TOLEDO CITY PLAN COMMISSION REPORT

January 16, 2025

- Request - Major Site Plan Review for Multi-Family Housing
- Location - 1401 Monroe Street
- Applicant/Owner - Lucas Metropolitan Housing Authority
424 Jackson Street
Toledo, OH 43604

The Applicant is requesting a Major Site Plan Review for a new multi-family building located at 1401 Monroe Street to be named “Mission Point”. The ±1.772 acre site is located northwest of the 14th and Monroe Street intersection and is situated within the UpTown District Urban Neighborhood Overlay District. The site is currently used as a parking lot. Surrounding land uses include the Cherry Street Mission Ministries and Life Revitalization Center to the west; auto repair and a medical and dental clinic to the north across Monroe Street; the future Lucas County Canine facility, currently under construction, to the east across 14th Street; and a heating and cooling business to the south across Washington Street.

SITE PLAN

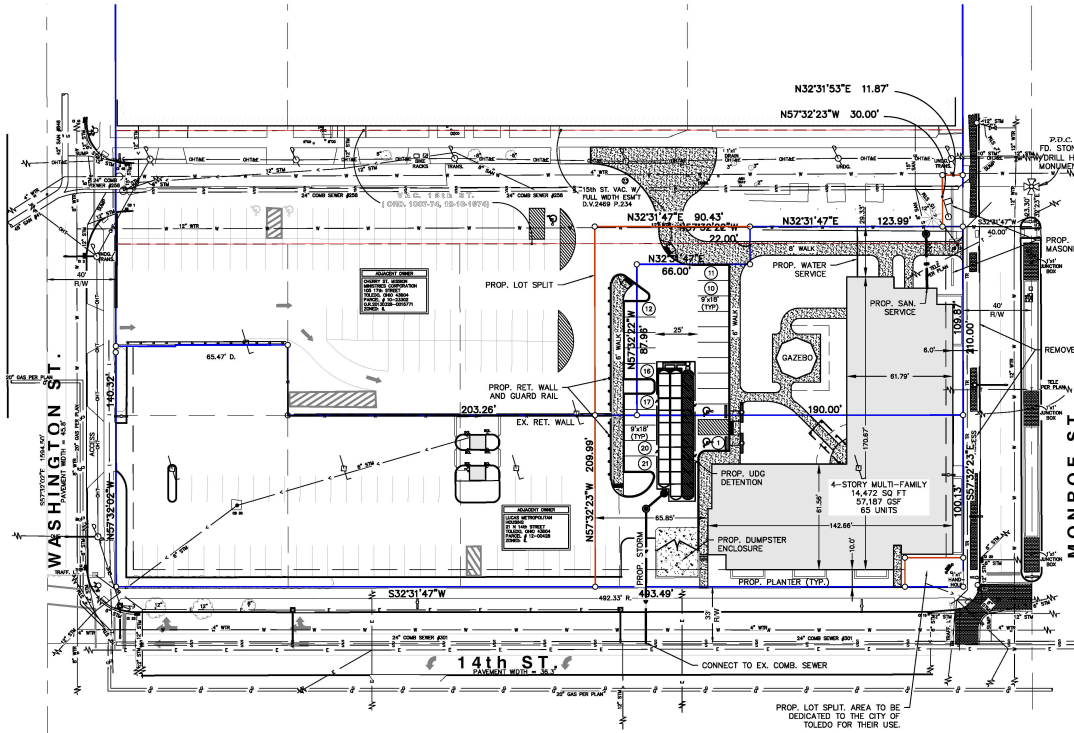
The site plan depicts seventy-three (73) parking spaces for the proposed building. Per the Off-Street Parking Schedule A in TMC§1107.0304, multi-dwelling structures are required to provide one and one-half (1.5) parking spaces for each dwelling unit plus one (1) parking space per ten (10) units for visitor parking. Calculations using 1.5 parking spaces for each dwelling unit (98) and visitor parking (7) result in one hundred five (105) parking spaces required to meet the minimum number of off-street parking requirements. To meet this requirement an additional thirty-two (32) parking spaces would need to be provided. Since the development is intended to provide supportive housing to the chronically homeless population, it is plausible that not all tenants will have their own vehicle and may instead use public transportation. In addition, the services provided by Cherry Street Mission Ministries are an integral component of the proposed development and as such parking is proposed to be shared between the facilities. The Plan Director is authorized to approve parking reductions if the applicant demonstrates the proposed plan will not adversely affect surrounding neighborhoods, traffic congestion and circulation, and will have a positive effect on the economic viability of the project per TMC§1107.1400. This is documented through the submission of an Alternative Access and Parking Plan. An alternative parking plan will need to be submitted to the Plan Director for review and approval prior to any building permits being issued as a condition of approval. This plan must detail the type of alternative proposed and the rationale for such a proposal, including supporting research on or documentation of parking demand for the proposed use(s) as well as a shared parking agreement.

5. The stormwater planning is adequate for the Site Plan Review (SPR) phase, but the proposed sewer connection in 14th street may require change to connection at vacated 15th. Connection point may need to be at an existing structure. Proposing a new structure on the brick sewer may require structural lining first.

39. Off-street parking shall be provided per TMC§1107.0304 Schedule A for the proposed multi-family building. A total of one hundred five (105) parking spaces are required. The site plan depicts seventy-three (73) parking spaces. **Not acceptable as depicted. An Alternative Access and Parking Plan, in accordance with TMC§1107.1400, shall be submitted to the Planning Director to allow for a reduction of the required minimum off-street parking spaces, including a shared parking agreement.**

40. Bicycle parking slots shall be provided per TMC§1107.0304 Schedule A for the proposed multi-family use. Eight (8) bicycle parking slots are required. The site plan does not depict any bicycle parking slots. **Not acceptable as depicted. Site plan shall be revised to include the required eight (8) bicycle parking slots.**

41. All spaces reserved for the use by persons with physical disabilities shall adhere to the standards outlined in TMC§1107.1700. A minimum of two (2) car accessible spaces and one (1) van accessible space is required for the site. The site plan depicts two (2) van accessible spaces. **Not acceptable as depicted. The site plan shall be revised to include one (1) additional accessible space in the parking area closest to the building.**

50. The proposed dumpster area shall be relocated so that it is not located along 14th Street and depicted on a revised site plan to be submitted to the Plan Commission for review and approval by the Plan Director.

PRELIMINARY DRAWING OF:
FIELDVIEW ADDITION
BEING A REPLAT OF
GARDENVIEW ACRES
LOT 1
CITY OF TOLEDO, LUCAS COUNTY, OHIO

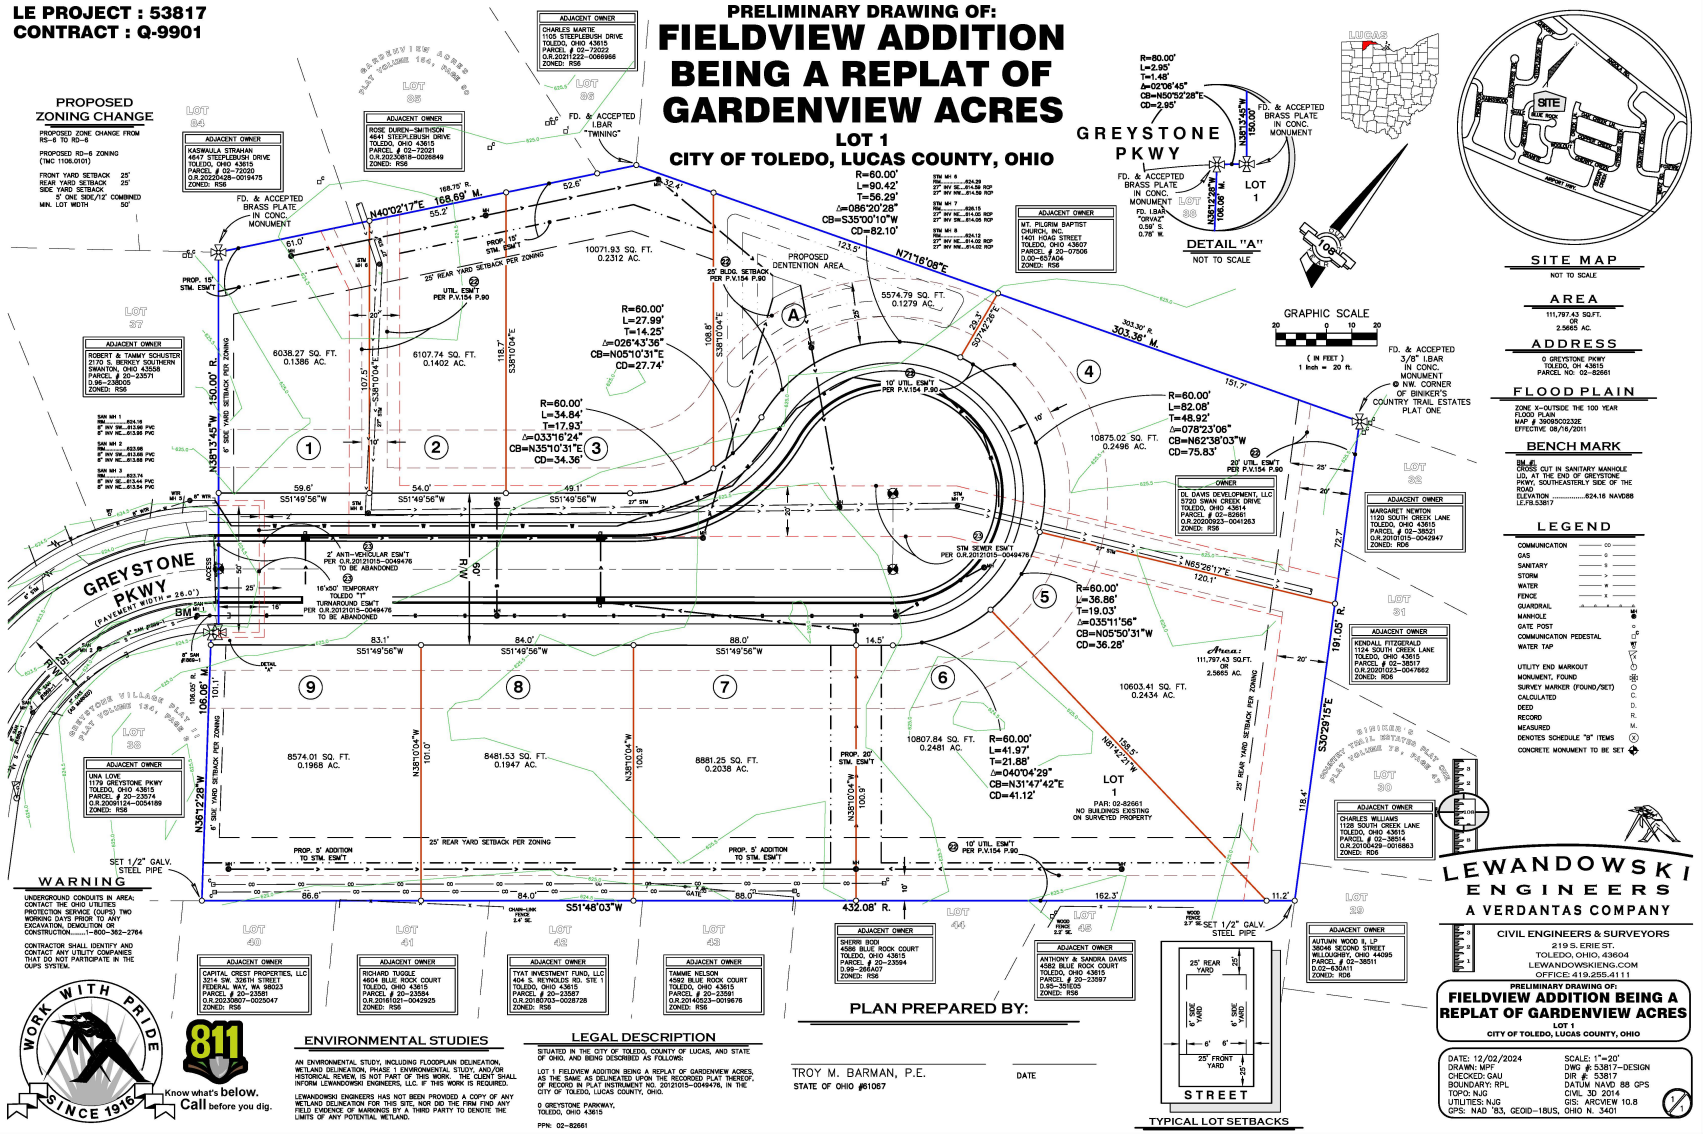
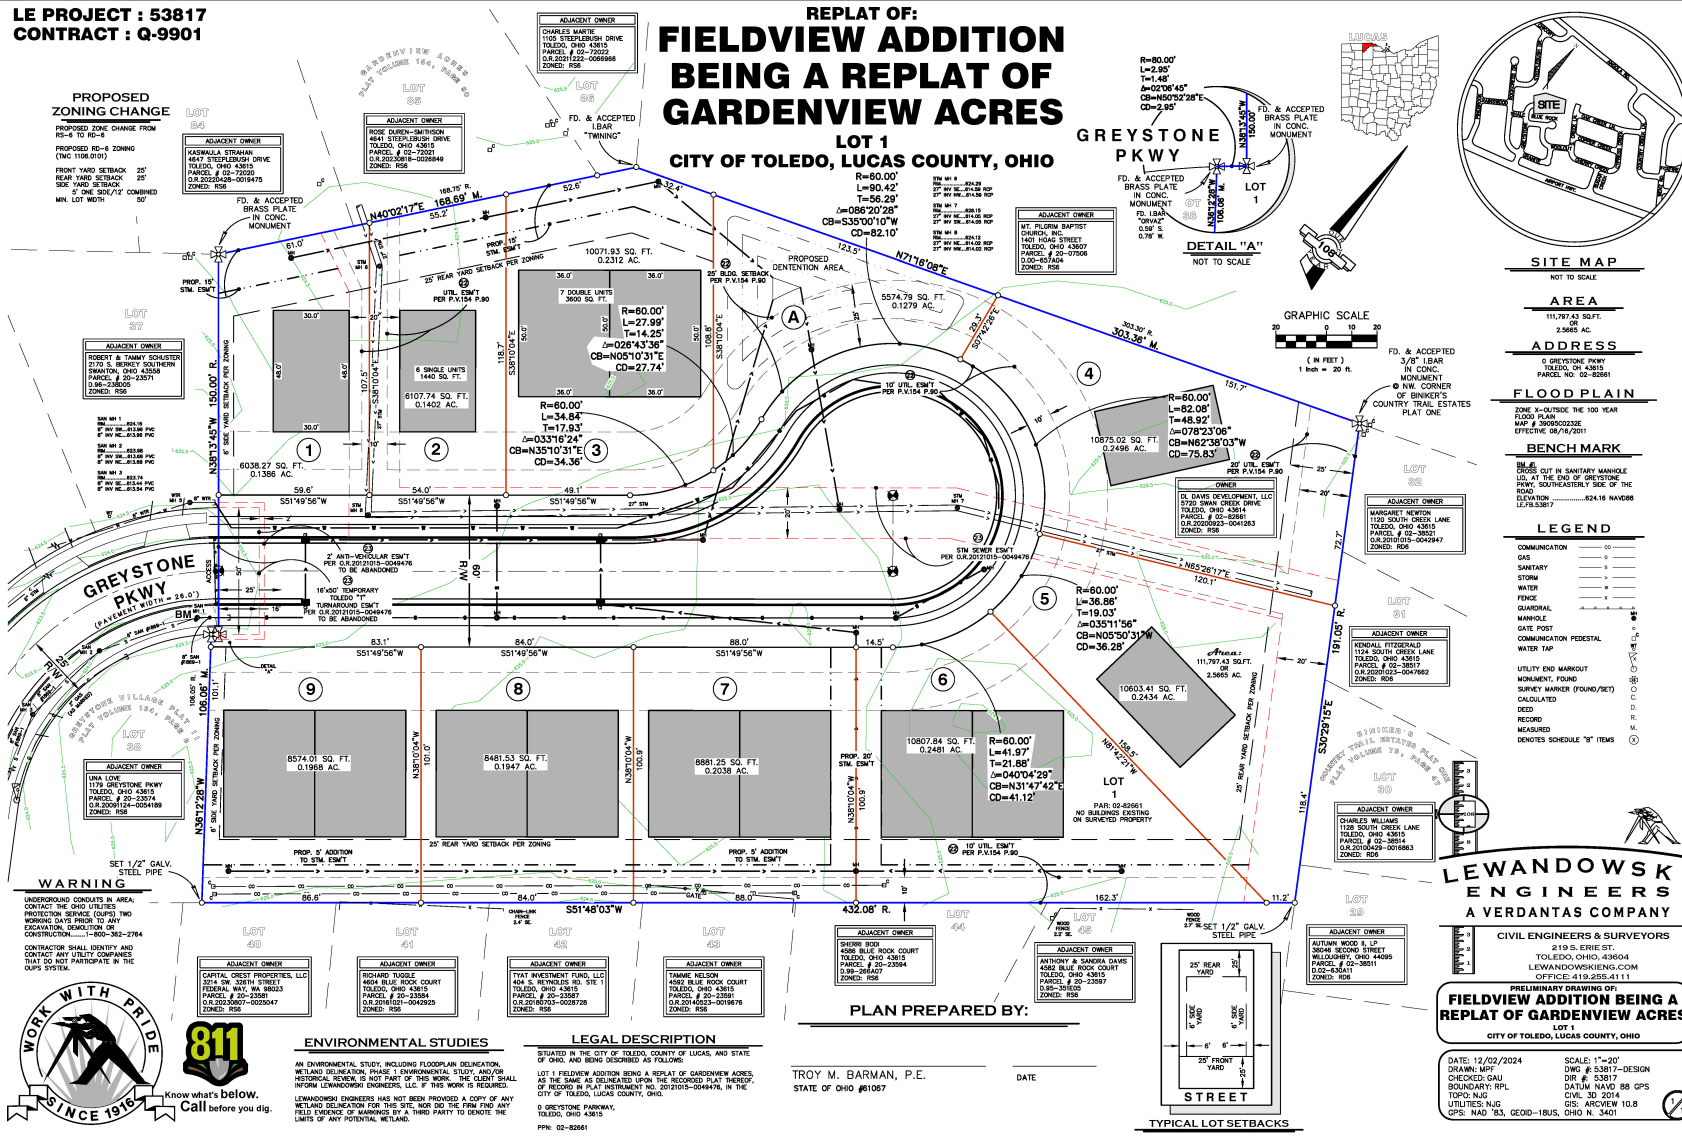
7. The stormwater planning is adequate for a preliminary plat, although Toledo has not received engineering work by which it could be confirmed that the proposed detention will suffice for stormwater management needs. Confirmation is recommended prior to the final plat. The basin design shall conform the Toledo Infrastructure Standards and Ohio CGP and it shall be drained by gravity unless a defense is made and accepted that a pump must be used. Should any stormwater landscape changes be made in the process of receiving engineering approval, further coordination with the Plan Commission may be required to receive engineering approval.

12. Markups on the preliminary drawing submitted by the Chief Surveyor on 12/11/24 shall be addressed on the final plat.
